RE: CUYAHOGA COUNTY  
ROCKY RIVER WATERSHED  
CITY OF BEREA  
SANDSTONE RIDGE SOUTH

**NOTICE OF VIOLATION**

**SANDSTONE RIDGE SOUTH PH 3A & 3B**  
City of Berea Cuyahoga County  
Operator: Lopat LLC

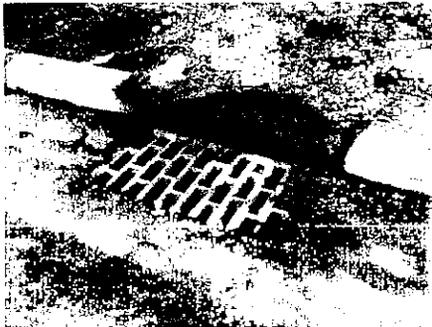
**Fig 10 & 11.** Disturbed areas outside the road and utility right-of-ways and the privacy mound along the railroad tracks have not been stabilized. These areas will remain idle 21 days or longer and are required to be temporarily stabilized between construction operations. Note that runoff from the privacy mound enters the drainage channel along the tracks. Silt fence should be installed at the base of the mound to prevent the migration of sediment into the drainage channel.
